URGENT PRODUCT CORRECTION NOTIFICATION

Potential Sample Metering Anomaly on VITROS® Systems using Software Version 3.2.2 and Below

Product Name	Product Code	Affected Software Version	Unique Device Identifier No.
VITROS® 3600 Immunodiagnosics System	6802783 6802914 (Refurbished)	Software Version 3.2.2 & Below	10758750002979 10758750007103
VITROS® 5600 Integrated System	6802413 6802915 (Refurbished)		10758750002740 10758750007110

4. How can I determine tray positions in the Sample Supply?

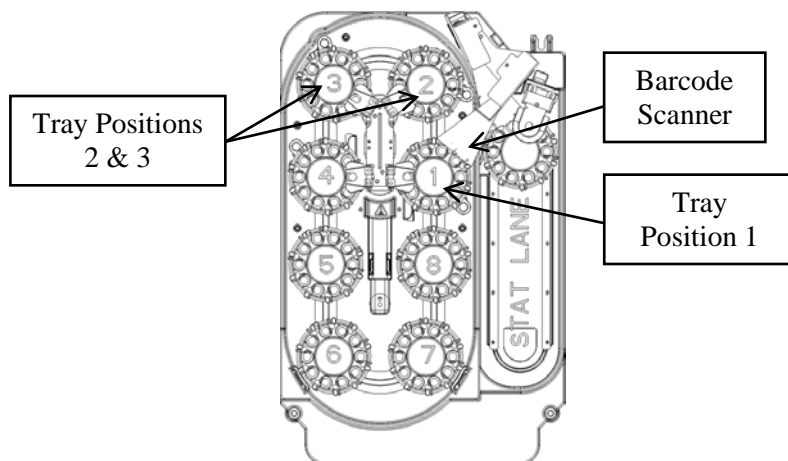
The affected positions located in the Routine Lane of the Sample Supply as shown below:
